Form Title:	<b>ENGINEERING BULLETIN</b>	Document #: <b>EB-02-20</b> <small>(Form: DEF-003A-1)</small>
	Document Title:	<b>Change from 60 LED to 44 LED Lens Assemblies</b>	Revision: <b>0</b>
			Date: <b>June 4, 2020</b>
			Page: <b>1 of 2</b>

**Description of Bulletin:** This bulletin is to alert of the change from 60 LED lens assemblies to the new 44 LED lens assemblies and to educate regarding the change to the part numbers for these lens assemblies.

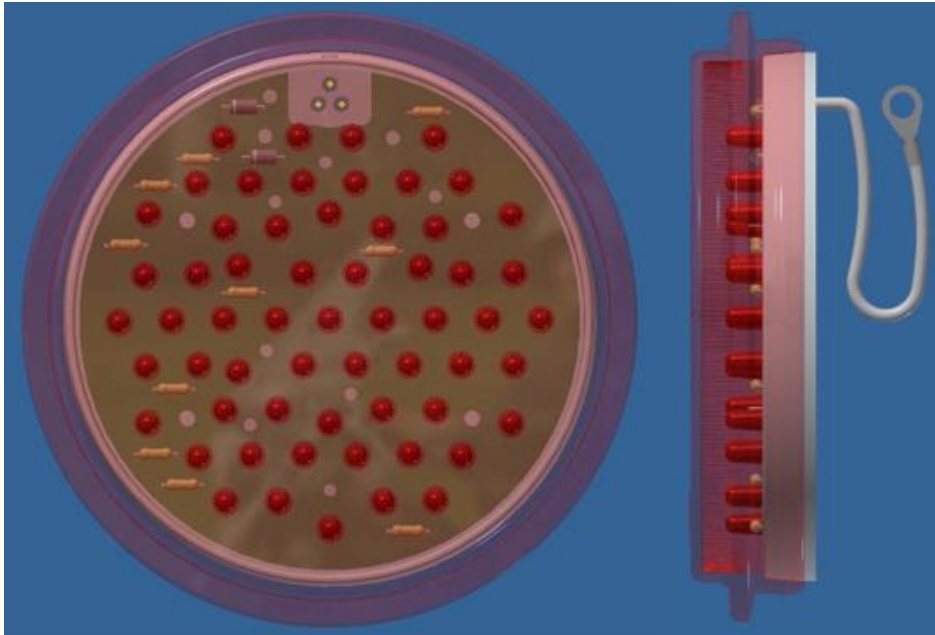
**Background Details:** The original design of the multi-LED lens assemblies was 60 LED thru hole technology for the LEDs and components. The new design is a 44 LED surface mount technology for the LEDs and components. This surface mount technology allows the design to be multi-volt with improved light output, improved surge protection and conformal coating for corrosion resistance.

**Bulletin Details:** 60 LED lens assemblies will be phased out to be replaced by the new 44 LED lens assemblies. The form, fit and function are not affected by this change.
